Access Compliance Report

Public Rights-of-Way

Intersection ID: 2718	Main Street: SKYLINE_DR	Cross Street: HIGHLAND_CREEK_PY	Location: SW
ADA ID: C1CA1AB806EF	Ramp Type: Perp	Initial Pass/Fail: Fail	Overall Compliance: No
		Severity Score: 22.5

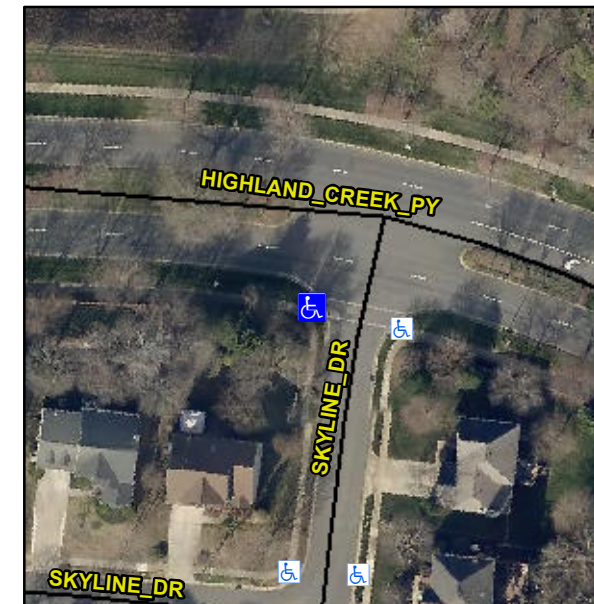
R304.5.1, R304.2.2, R304.5.3

Compliance	Description	Data	Compliance	Description	Data
N/A	Ramp Length (in)	77.0	No	Ramp Slope (%)	9.4
No	Ramp Width (in)	41.0	No	Ramp XSlope (%)	3.6
N/A	Flare Type LT	N/A	N/A	Flare Type RT	N/A
N/A	Flare Slope LT (%)	N/A	N/A	Flare Slope RT (%)	N/A
N/A	Flare Traversable LT?	N/A	N/A	Flare Traversable RT?	N/A
N/A	Landing Length (in)	N/A	N/A	DWS Provided?	N/A
N/A	Landing Width (in)	N/A	N/A	DWS Contrast?	N/A
N/A	Landing Slope (%)	N/A	N/A	DWS Length (in)	N/A
N/A	Landing X Slope (%)	N/A	N/A	DWS Full Width?	N/A
N/A	Landing Curb? (Y/N)	N/A	N/A	DWS Offset (in)	N/A
N/A	Shared Landing?	N/A			
N/A	Gutter Ponding?	N/A	N/A	Gutter Slope (%)	N/A
N/A	Gutter Lip Ht (in)	N/A	N/A	Gutter X Slope (%)	N/A
N/A	Painted X Walk1?	Yes	N/A	Painted X Walk2?	N/A
	X Walk 1 Direction	To SE		X Walk 2 Direction	N/A
N/A	X Walk 1 Width (in)	95.0	N/A	X Walk 2 Width (in)	N/A
	X Walk 1 Slope (%)	1.6		X Walk 2 Slope (%)	N/A
	X Walk 1 X Slope (%)	2.8		X Walk 2 X Slope (%)	N/A

Remove & Replace Entire Ramp.
